NRC Briefing on Proposed Rule  
on Part 35 Medical Events  
Definition-Permanent Implant  
Brachytherapy

July 8, 2010

Brian J. Davis, M.D., Ph.D.

REPROPOSED RULE:  
AMENDMENTS/MEDICAL EVENT  
DEFINITIONS (RIN 3150- AI26)

REPROPOSED RULE:  
AMENDMENTS/MEDICAL EVENT  
DEFINITIONS (RIN 3150- AI26)

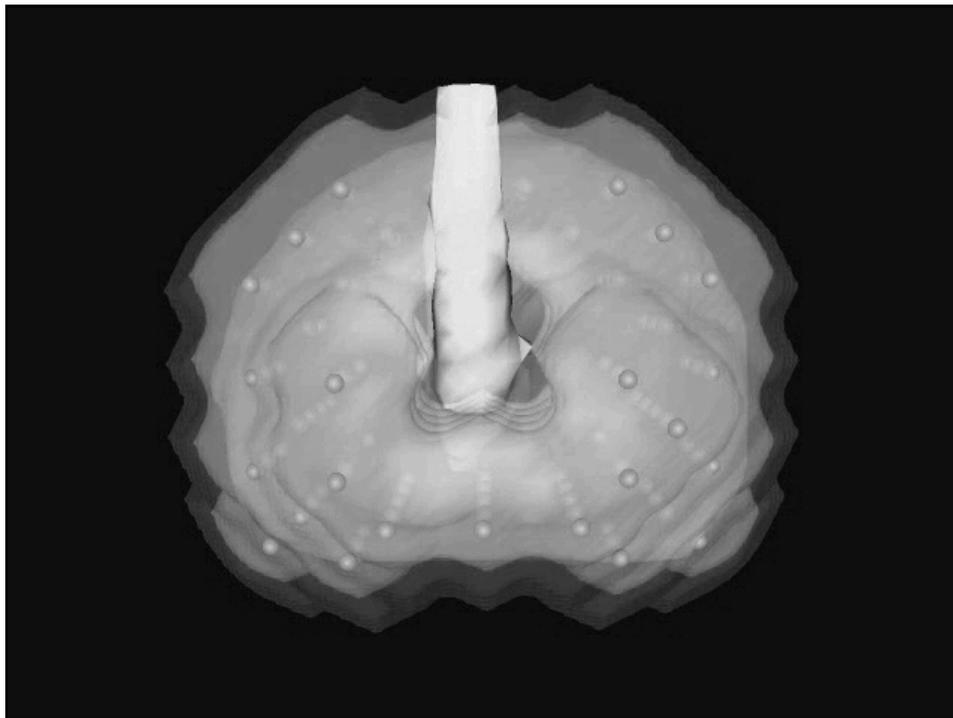
- Why is this wrong?
  - Volume change after a permanent seed implant is unpredictable, so a dose determination at a single time point may easily vary by more than ***an arbitrary*** 20%.
  - It will result in an over-reporting of ME's ***without any justifiable clinical basis.***
  - Excellent long-term results are reported for cases where intended dose prior to an implant varies by more than 20% after an implant.
